1970 Corvette: Service Bulletin: 1970 Corvette Folding Top Material Interference with Lid Pin Support

Bulletin No: 70-T-46

Date: Oct. 27, 1970

FIGURE 1

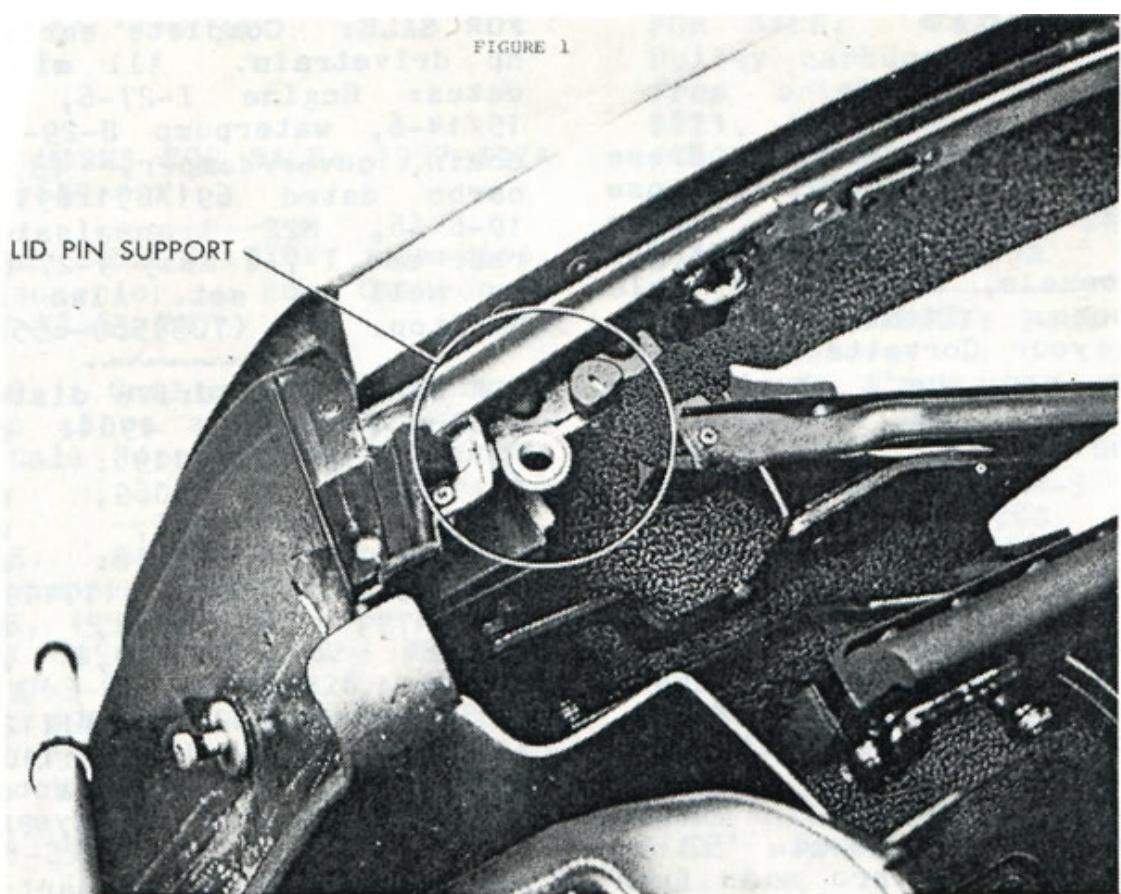
1970 Corvettes assembled prior to Serial Number S400748 may have interference between the folding top material and the top compartment lid pin support. This interference may result in damage to the folding top material.

Vehicles built prior to the above serial number, should be inspected and if interference exists, the top compartment lid pin support should be reworked using the following procedure:

1. Remove the lid pin support. (See Figure 1).
2. Grind 3/8" x 3/4" off the inboard edge of the support. (See Figure 2).
3. Reinstall the lid pin support and inspect to insure adequate clearance exists between the folding top material and the support.
